Access Compliance Report

Public Rights-of-Way

Intersection ID: 44910	Main Street: FOX_POINT_DR	Cross Street: OAKBURN_DR	Location: W
ADA ID: 7AD75003D60F	Ramp Type: PerpDiag	Initial Pass/Fail: Fail	Overall Compliance: No
Severity Score: 18.75			
Codes/Mitigation Info/Possible Solution		Field Measurements/Component Compliance

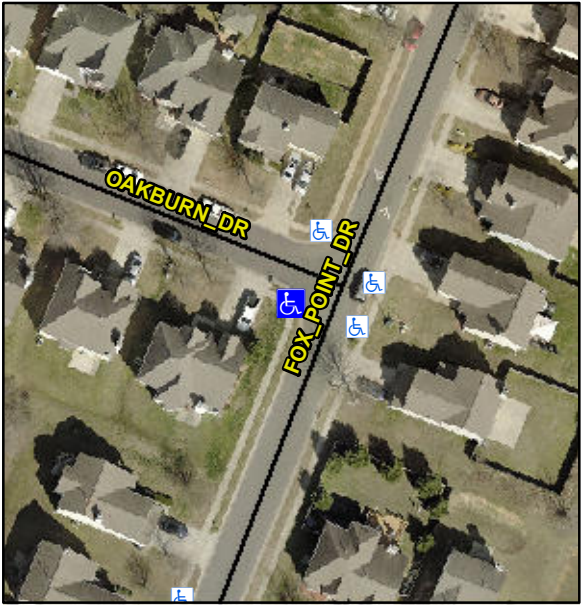
Possible Solutions:	Compliance	Description	Data	Compliance	Description	Data
	Remove & Replace Curb Ramp With Two New Directional Ramps or Equivalent.	N/A	Ramp Length (in)	47.5	Yes	Ramp Slope (%)	5.9
		No	Ramp Width (in)	35.0	No	Ramp XSlope (%)	4.1
		N/A	Flare Type LT	N/A	N/A	Flare Type RT	N/A
		N/A	Flare Slope LT (%)	N/A	N/A	Flare Slope RT (%)	N/A
		N/A	Flare Traversable LT?	N/A	N/A	Flare Traversable RT?	N/A
		N/A	Landing Length (in)	N/A	N/A	DWS Provided?	N/A
		N/A	Landing Width (in)	N/A	N/A	DWS Contrast?	N/A
		N/A	Landing Slope (%)	N/A	N/A	DWS Length (in)	N/A
		N/A	Landing X Slope (%)	N/A	N/A	DWS Full Width?	N/A
<p>Surveyor Notes:</p> <p>N/A</p> <p>PROW/ADA:</p> <p>R304.5.1, R304.5.3</p>		N/A	Landing Curb? (Y/N)	N/A	N/A	DWS Offset (in)	N/A
		N/A	Shared Landing?	N/A			
		N/A	Gutter Ponding?	N/A	N/A	Gutter Slope (%)	N/A
		N/A	Gutter Lip Ht (in)	N/A	N/A	Gutter X Slope (%)	N/A
		N/A	Painted X Walk1?	No	N/A	Painted X Walk2?	No

X Walk 1 Direction	To E		X Walk 2 Direction	To N
		N/A	X Walk 1 Width (in)	N/A	N/A	X Walk 2 Width (in)	N/A
			X Walk 1 Slope (%)	4.3		X Walk 2 Slope (%)	1.1
			X Walk 1 X Slope (%)	1.3		X Walk 2 X Slope (%)	2.6
		N/A	Ramp inside XWalk1?	N/A	N/A	Ramp inside XWalk2?	N/A
<p>Street 1 Name</p> <p>Stop Condition-Street 2</p> <p>Street 2 Name</p> <p>Stop Condition-Street 1</p>			Road Slope (%)	3.3	N/A	Clear Space?	N/A
			Road X Slope (%)	2.0	N/A	Clear Space to XWalk (in)	N/A
		N/A	Any Obstructions?	N/A	N/A	Storm Grate/Utility Hazard?	N/A
			Obstruction Type			Storm Grate/Utility Type	
					N/A		N/A
					Yes	Surface Condition? (G/P)	Good
Total Cost:		\$	3200.00
